Development Brief
July 2012

for Housing at **Land Off Ffordd Eldon** the Former Sewage Works Site, Wats Dyke Lane, Sychdyn

**Comments on the
Former Sewage Works Site, Wats Dyke Lane,
Sychdyn Development Brief**

(See Site Context and Analysis diagram)

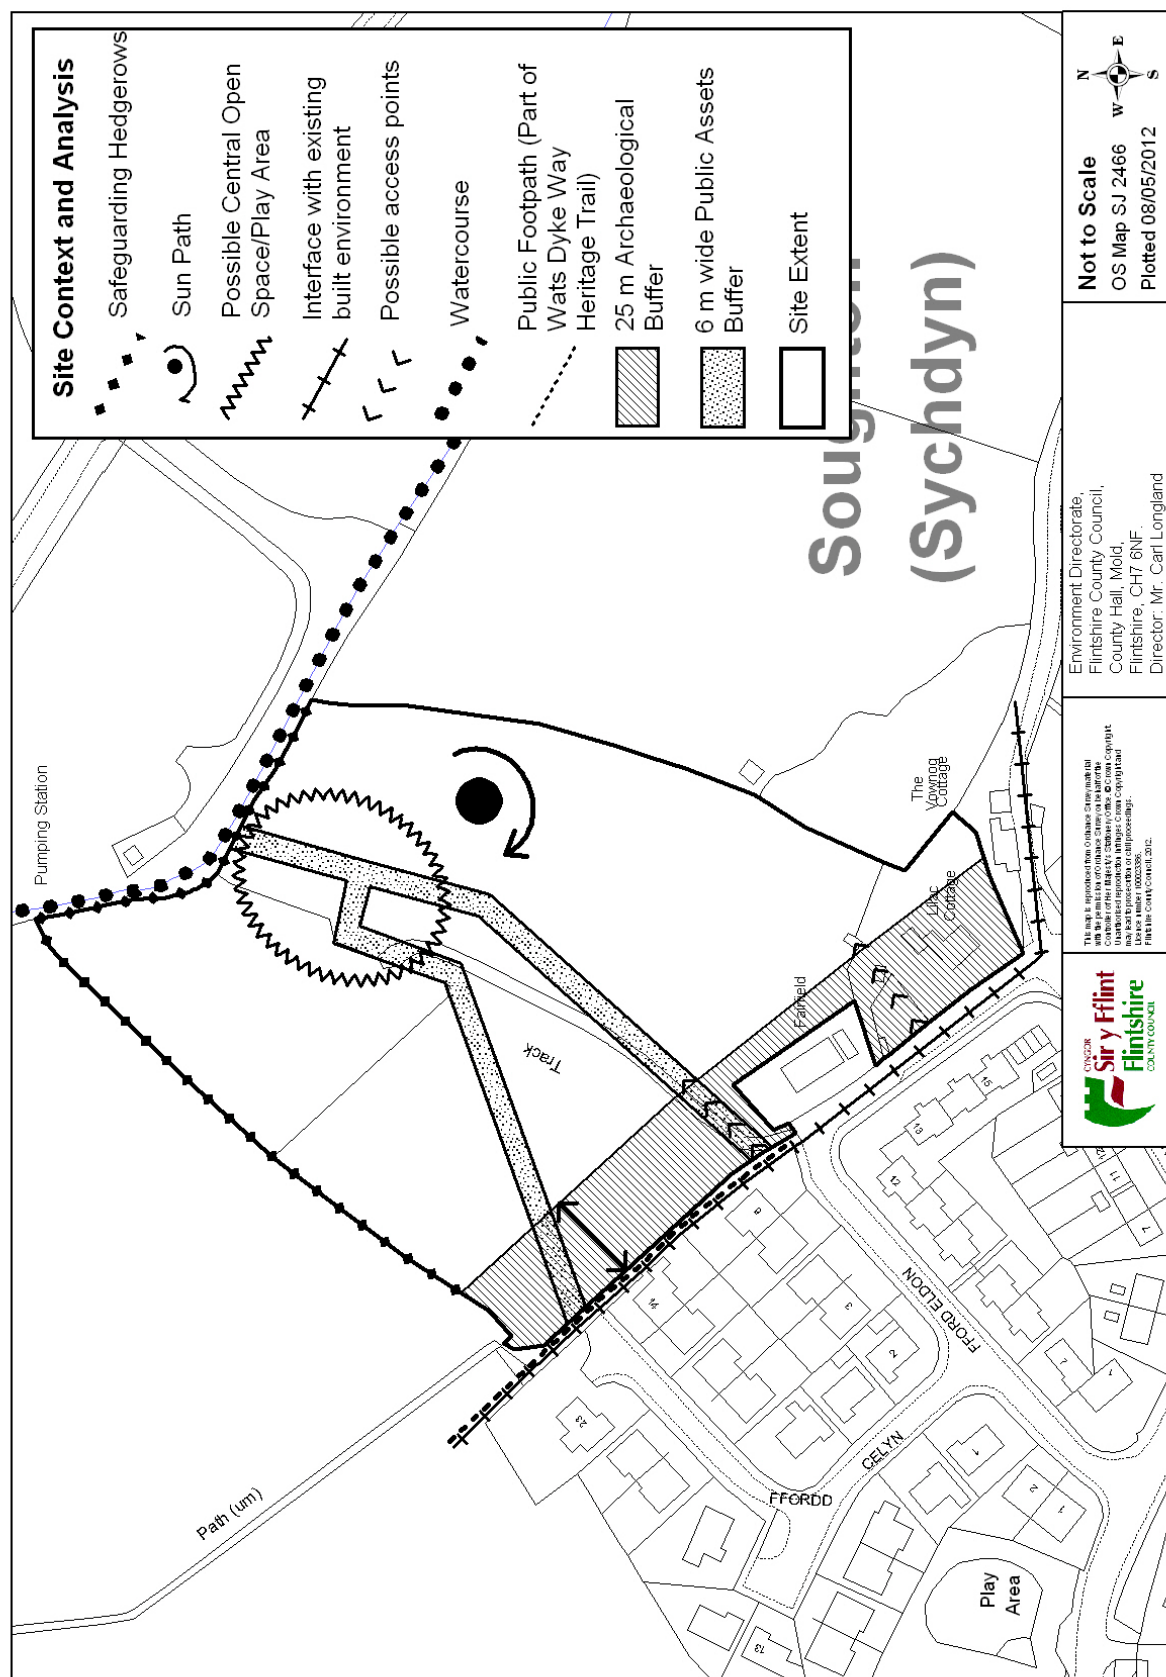
<p>6.13 Public Open Space Requirements. Why is it necessary to include a play area in the site when an excellent play ground is already available within 200 metres of the site?</p>	<p>The requirement as set out in this brief shows the area of play space as required by Policy SR5 Outdoor Playing Space and New Residential Development which is 2.4 hectares per 1000 population. The total area depends on the number of units proposed and is a requirement for all new developments. There is a play ground nearby but there is also a shortfall of play areas when considering the village as a whole. It may be that a smaller play area could be provided with a commuted sum to make up the rest of the contribution to be spent off-site. This will depend on negotiations with the Play Unit section of the Council at the time of the planning application. The location of the play area on the map is indicative only, it could be located elsewhere, therefore it is proposed to amend the legend on the map to show this is a possible location for the open space.</p>	<p>Amend the legend on the Site Context and Analysis Plan to say 'Possible Central Open Space/ Play area'</p>

<p>little to enhance the visual quality or biodiversity of the area. 6.5 The landowner would have no objection to a lesser buffer strip of no more than 10m provided that this can be properly justified. In addition agreement could be reached whereby the developer would provide for appropriate interpretation within a suitably landscaped setting and dedicate this area to the local community council.</p> <p>6.6 Alternatively this area could form the required public open space and play area which would not only be a good use of the land but would be in an ideal location and realise the Brief's aim to 'visually, functionally and physically integrate' the development into the existing built form of the village.</p>		
	<p>6.7 This leads conveniently to the requirement of the brief that the play area should be centrally located within the site. The play area and open space is but one element to be taken into account in the design and layout of the site. It should be considered at the conceptual design stage where sustainability, orientation, movement within and out of the site and many other issues are considered. It would be premature to be so prescriptive regarding the location of the play area at this stage of the design process as this could prejudice sustainable design solutions, particularly in light of the need to have regard to national policy and advice on climate change.</p>	<p>Partly accepted. The purpose of the Development Brief is to provide clear advice to potential applicant on the requirements, expectations, opportunities and constraints of the site. The brief may suggest solutions but it cannot be totally prescriptive. The site context and analysis plan show an indication of where the open space/ play area might be located. A central location would ensure natural informal surveillance which is always advisable for play areas. The plan is indicative only and is not prescribing exactly where that use should be.</p> <p>Clarify on the key of the indicative plan by adding 'Possible' - to the central open space/ play area, notation.</p>	<p>Change annotation on the indicative plan to 'Possible central open space/ play area.'</p>
